CITY OF CODY
PLANNING, ZONING AND ADJUSTMENT BOARD
TUESDAY, NOVEMBER 26, 2013
CITY HALL COUNCIL CHAMBERS @ 12:00 NOON

MEETING DATE:	NOVEMBER 26, 2013	TYPE OF ACTION NEEDED	
AGENDA ITEM:		P&Z BOARD APPROVAL:	
SUBJECT:	PRELIMINARY PLAT OF J & K MAJOR SUBDIVISION— A 15-LOT SUBDIVISION. SUB 2013-06	RECOMMENDATION TO COUNCIL:	X
PREPARED BY:	TODD STOWELL, CITY PLANNER	DISCUSSION ONLY:

APPR. BY: DAB
 PROJ. NO.: 131109
 DRAWN BY: KES
 CHECKED BY: TJJ
 GDA ENGINEERS
 CODY, WYOMING
 GDA ENGINEERS
 DESCRIPTION: REVISIONS
 NO. DATE
 PARK COUNTY
 CODY, WYOMING
 COVER
 PRELIMINARY PLAT FOR J & K MAJOR SUBDIVISION
 SHEET NUMBER
1
 OF 13 SHEETS

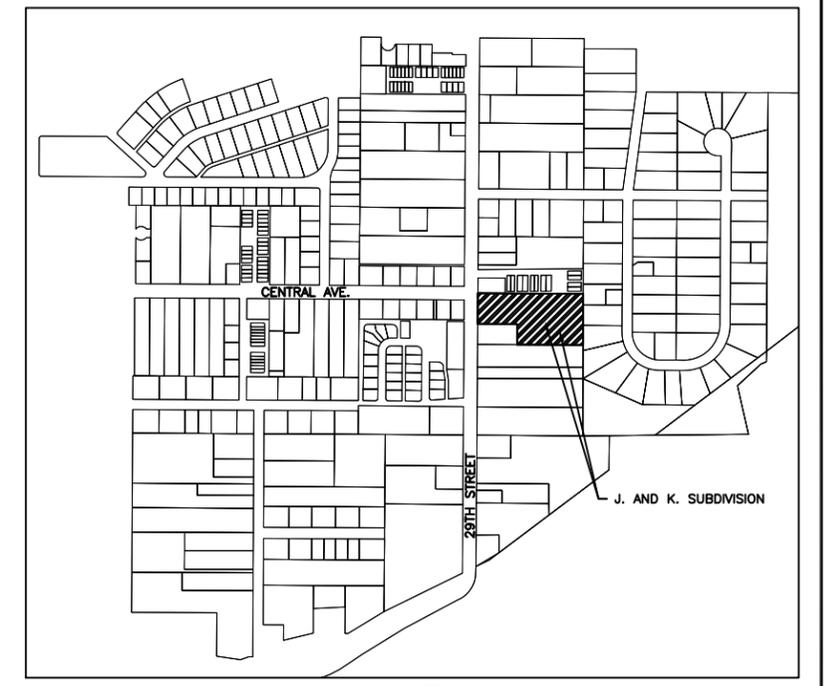
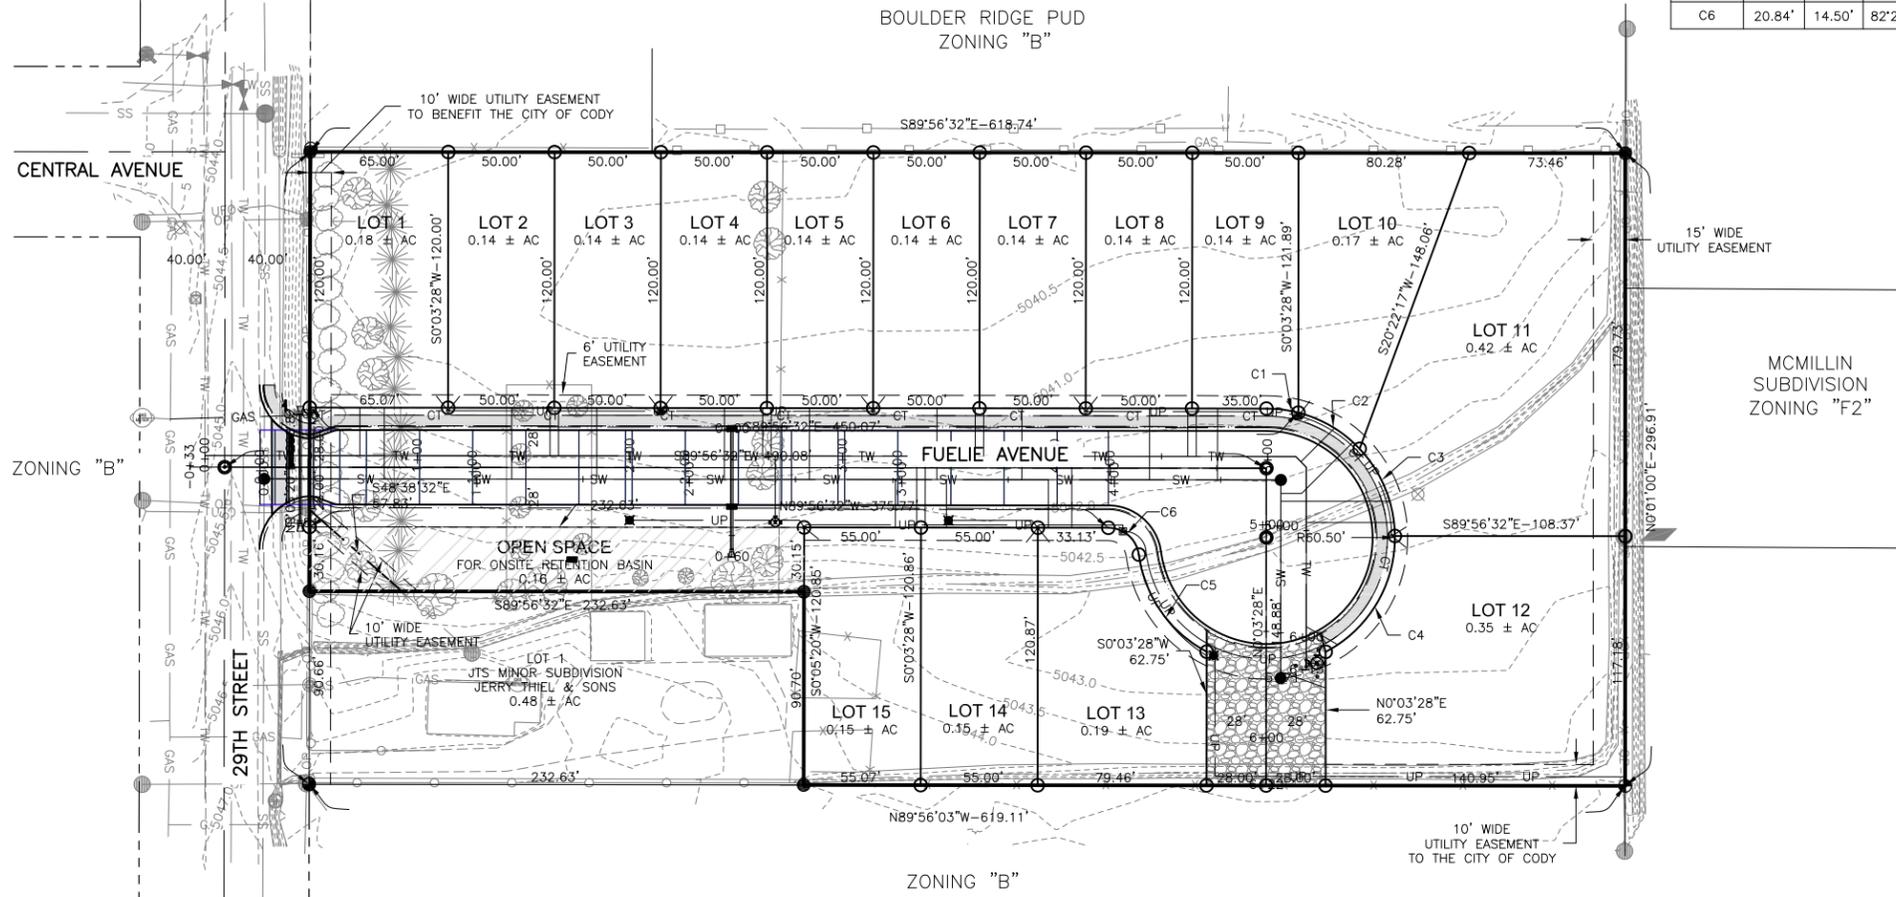
1. Make the following modifications to the preliminary plat, and provide a copy. The modifications are considered conditions of approval.
Sheet 1: Correct the street name in note #14.
Sheet 2: Update the variance language to reflect that above. Add sidewalk along Lots 13, 14 and 15, with a ramp crossing at the west end and directly across the street (mid-block crossing). A detail of the ramps will be needed also. Change the label from "Open Space" to "Tract A" or similar and indicate by note the method of ownership and maintenance of the tract.
Sheet 3: Add or expand a note to also include removal of all dead and dying trees. Add a note about protecting the existing piped irrigation ditch along 29th Street.

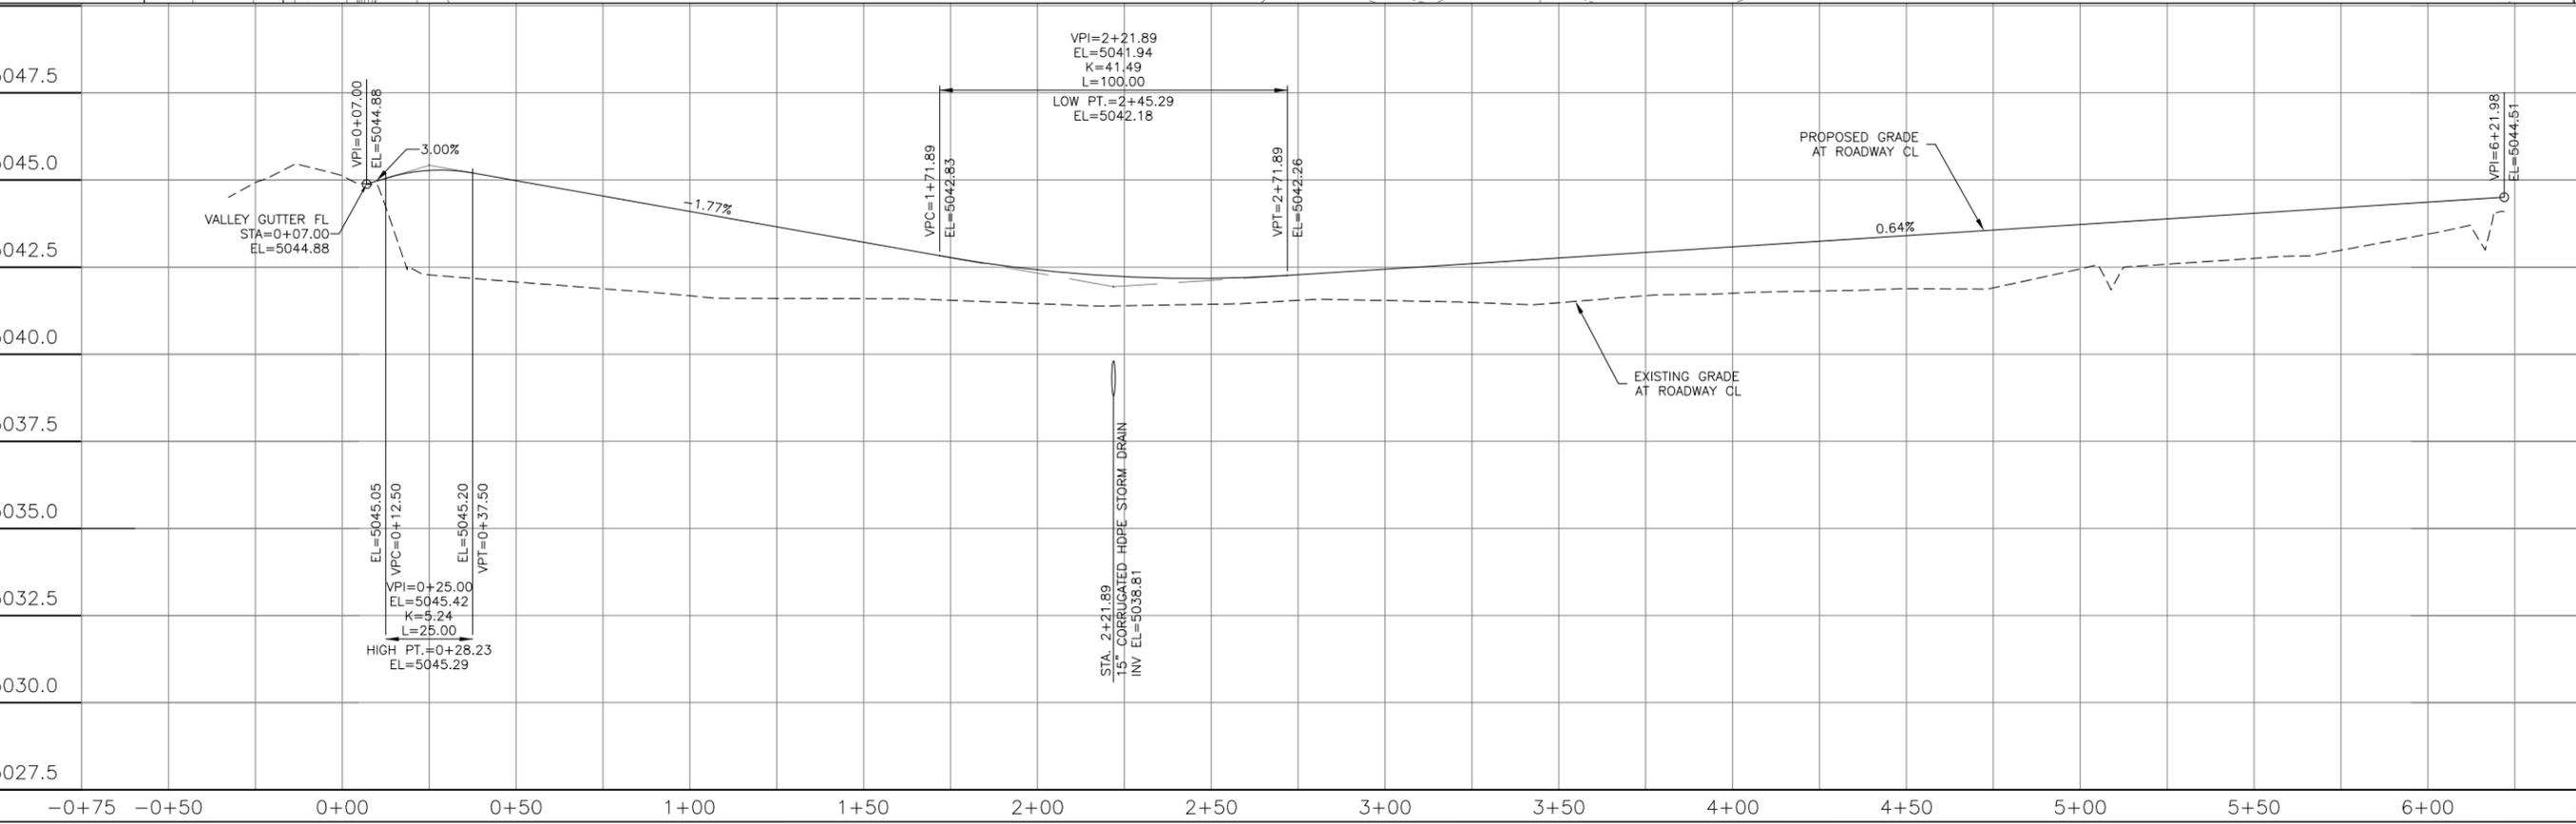
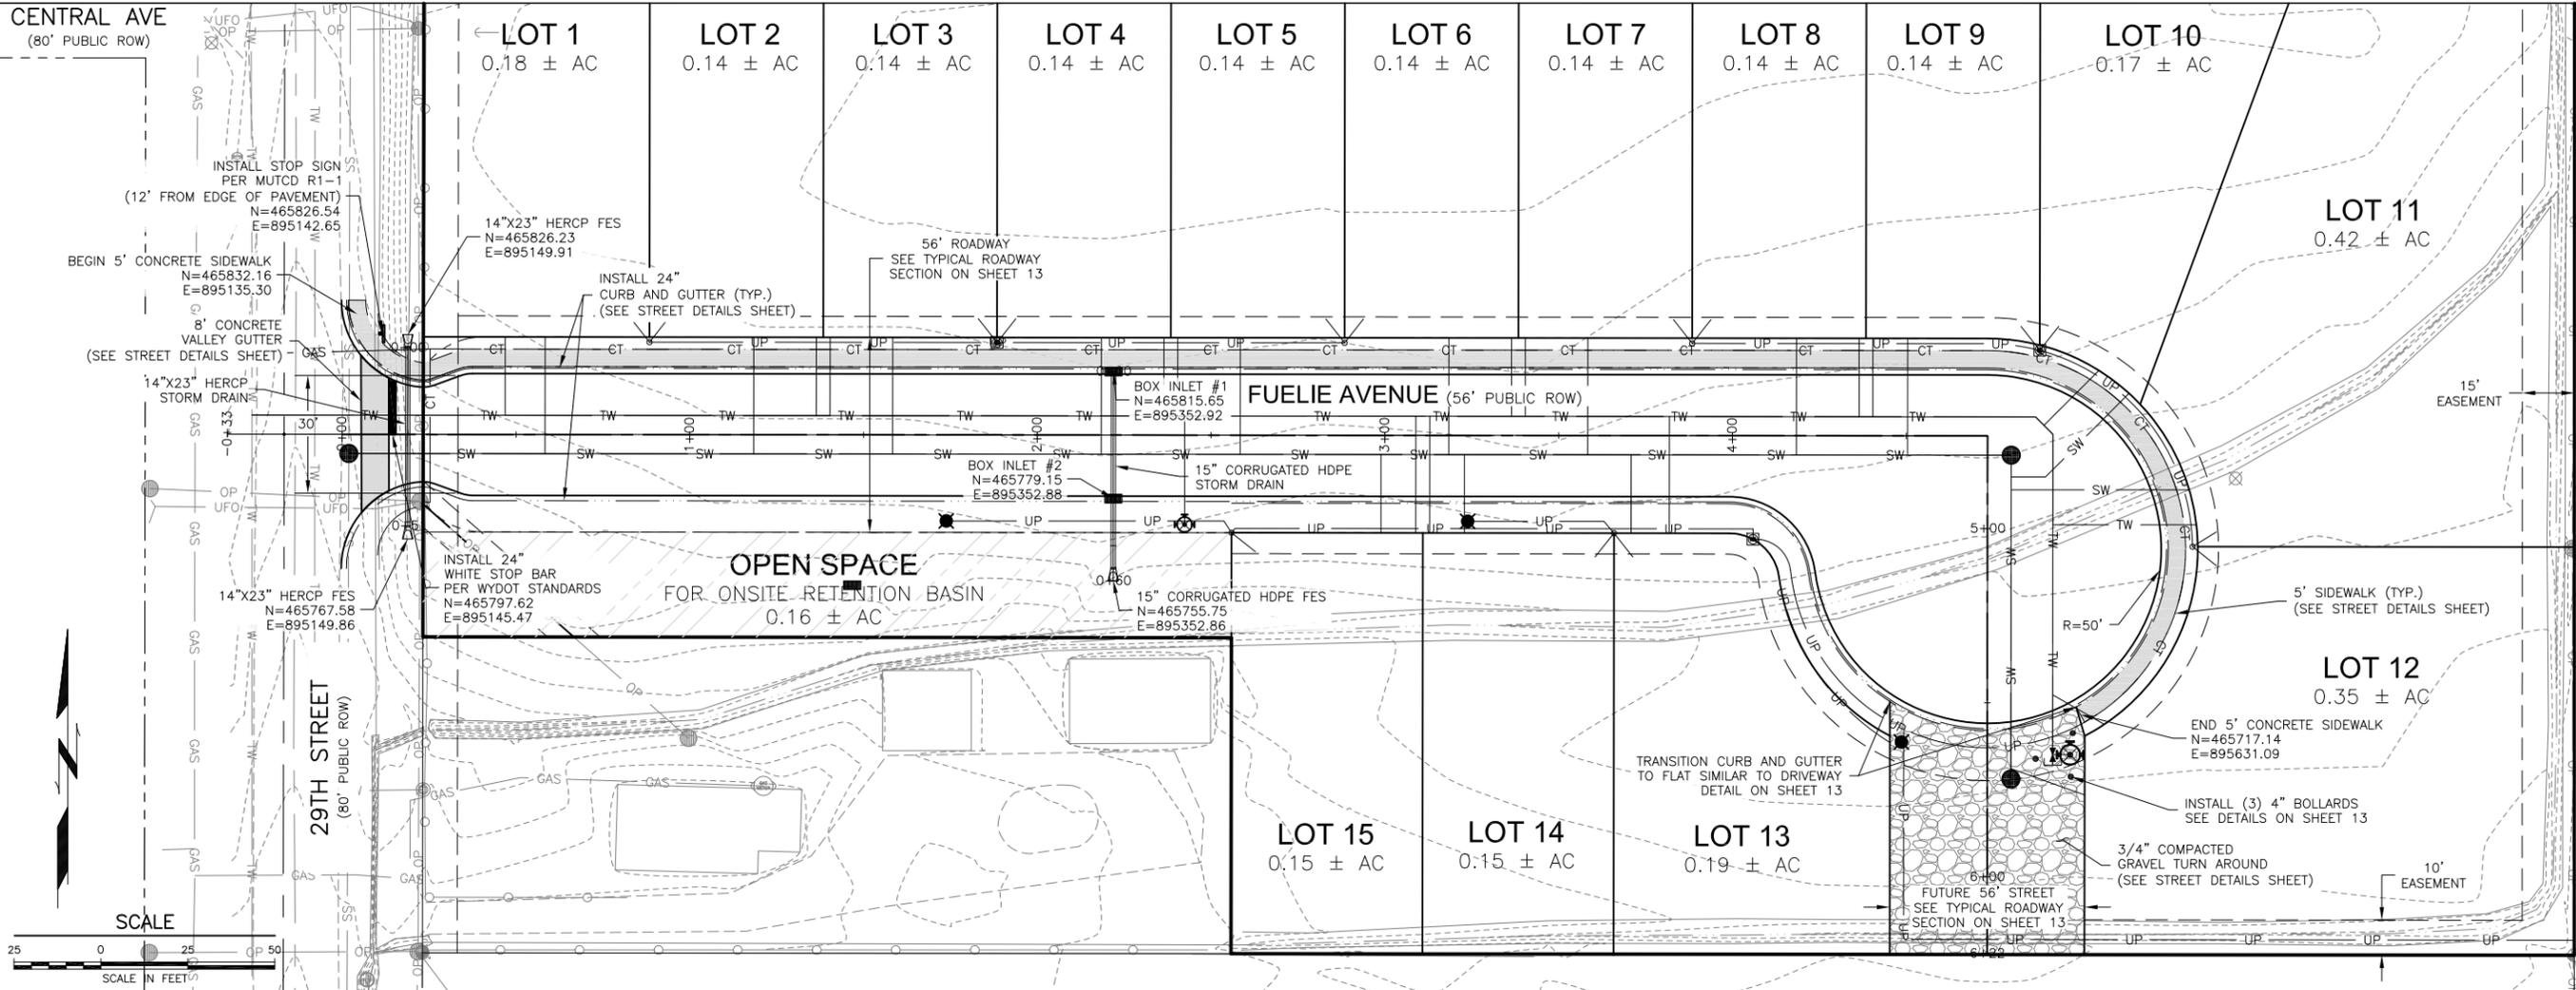
The applicant may have additional reasons for the narrowed street entrance as shown on Sheets 6 and 9, but it does avoid the need to relocate a power pole. The throat width is 30 feet, which according to the engineer can accommodate a tandem axle garbage truck, fire truck, and vehicle with boat trailer without crossing the centerline. A WB40 semi would need to cross the centerline by about 5 feet. A variance for the reduced entrance width is requested.

Comment: Met. The proposed street is a cul-de-sac. A "No Outlet" or "Dead End" sign should be installed to alert drivers, and noted on the plans. All signage is to be provided and installed by the developer.

Sheet 6: Add "Dead End" or "No Outlet" signs. Add "No Parking" signs in the gravel turnaround area.

MANHOLE COLLAR DETAIL FOR MANHOLES IN PAVED ROADWAYS
N.T.S.

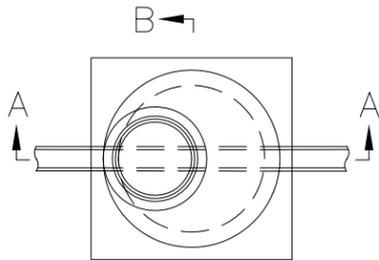
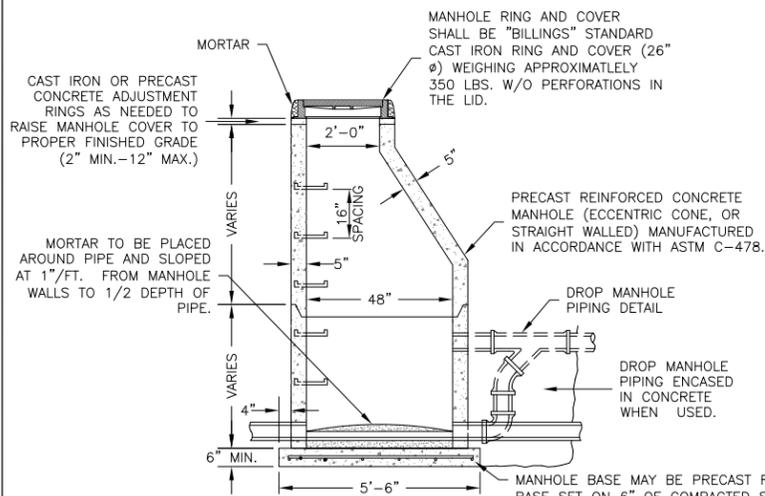
Sheet 10: Modify the manhole collar detail to refer to "all manholes"—not just in those in the paved roadways.
